# **TOWNSHIP OF McNAB/BRAESIDE COMMITTEE OF ADJUSTMENT AGENDA**

**Application for Minor Variance**

**Reference: 90A Mitchell Lane  
Application for Minor Variance – Planning Justification Letter  
Our File No.: 124055**

# MINOR VARIANCE PLANNING REPORT

**Figure 1:** Excerpt of Subject Site Survey (See enclosed for full survey)

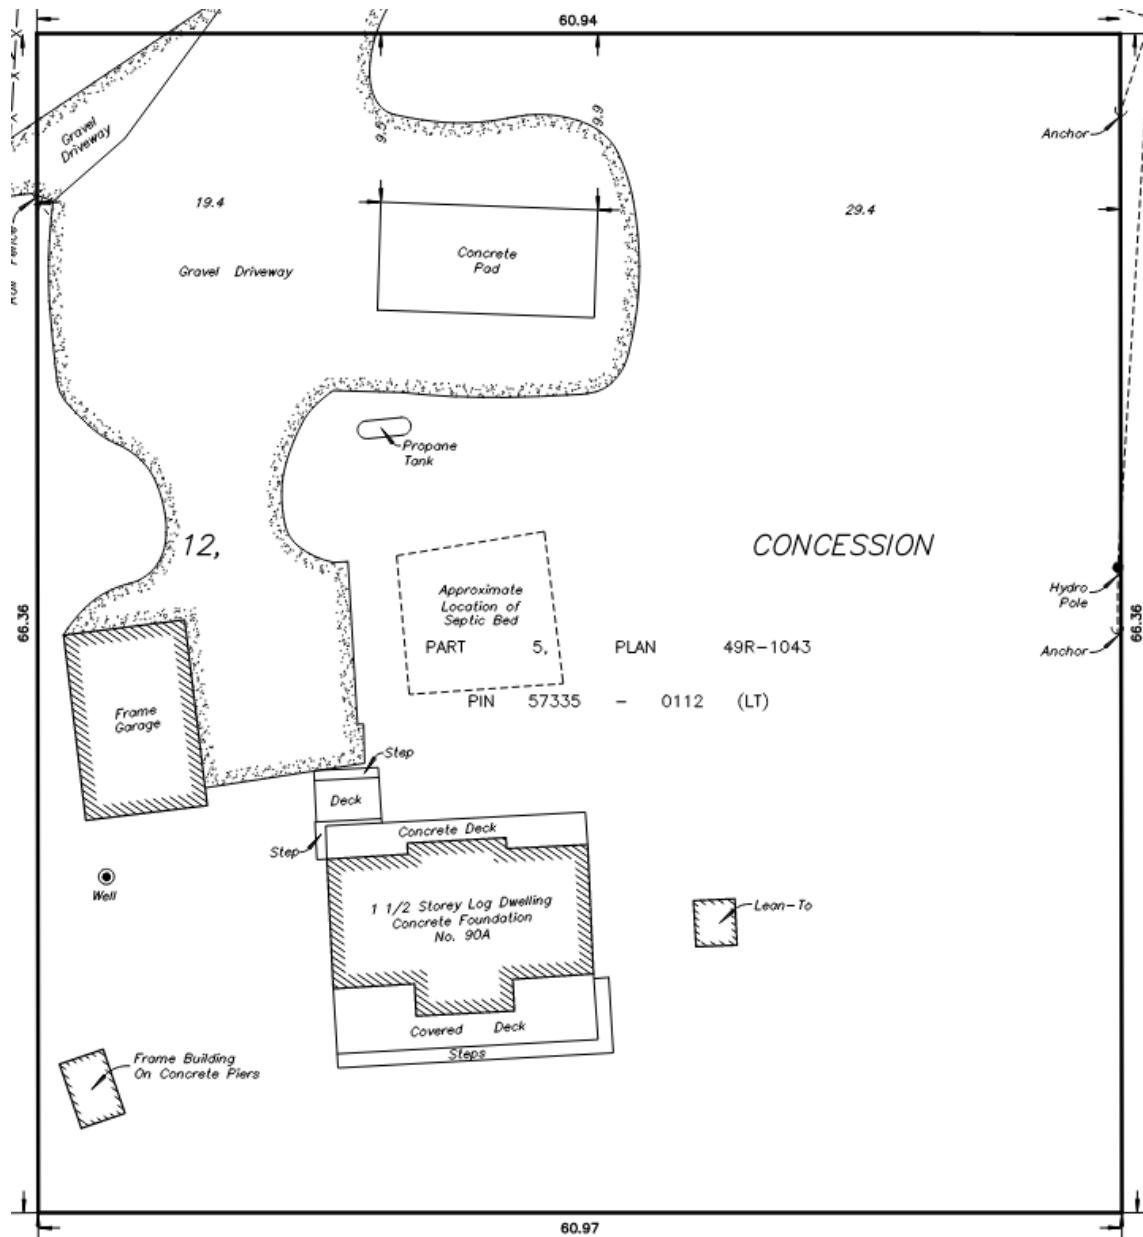
The relief for the proposed front yard location identified in Item (i) is indicated on Figure 1 at the location of the existing concrete pad. The relief requested in relation to building height identified in Item (ii) is shown in Figure 3, which indicates a building height, as per the zoning by-law definition, of 18 ft (5.48m).

SOUTH ELEVATION

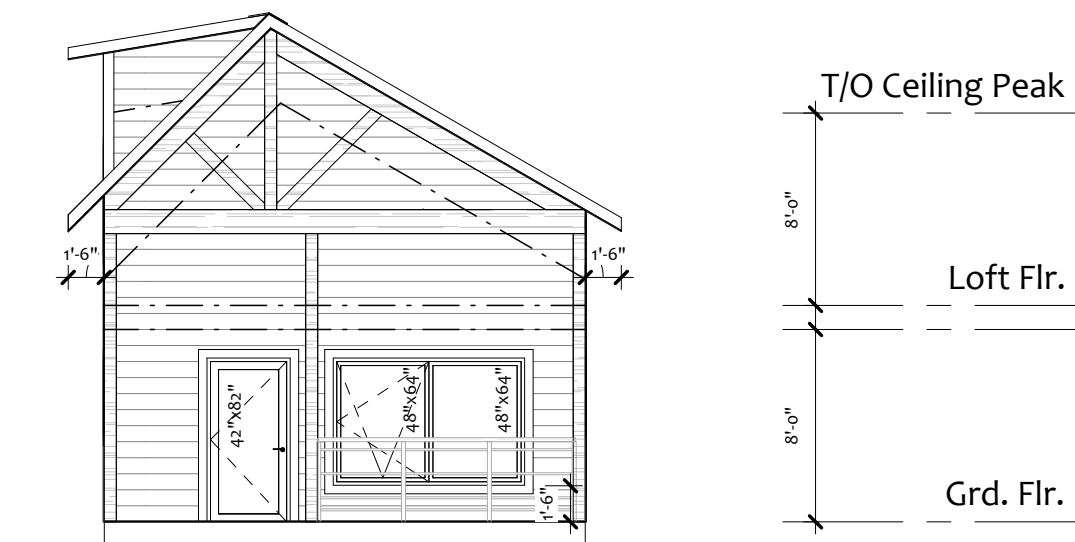
Lastly, the proposed height increase of 0.5 metres maintains the intent of the Zoning by-law, as it can still be screened from adjacent uses and indicates the building is clearly secondary to the principle dwelling. Based on these considerations, the proposed use meets the intent of the Official Plan and Zoning By-law.

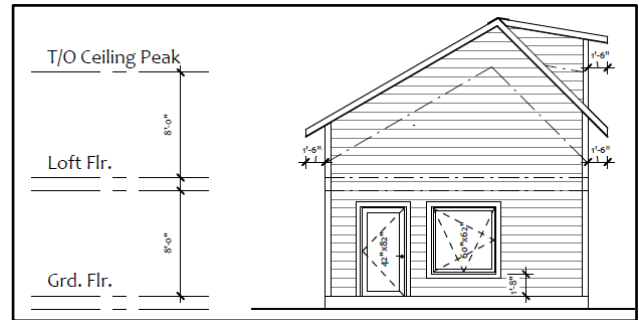
- secondary dwelling (coach house) will be located on the existing concrete pad (see red parcel on the right) and have the following setbacks :
  - Front Yard: 9.5 metres
  - Side Yards: 19.4 and 29.4 metres
- coach house will have a total floor area of approximately 96 squared metres
- private well and septic services will be shared with the principle dwelling

- no tree removal will be required
- surrounding land uses include two single detached dwellings and forested area
- coach house's height will be 5.48 metres (18 feet) (see right)

Prohibiting coach houses in the front yard of a residential zone was established with the assumption that there would be adequate space and visual screening to accommodate a coach house in the rear yard. The rear yard in the present situation is limited in space compared to the front yard, and there is a notable amount of vegetation along the front lot line to provide screening (see right). As such, the present proposal meets the intent of Section 3.34(d)(b).
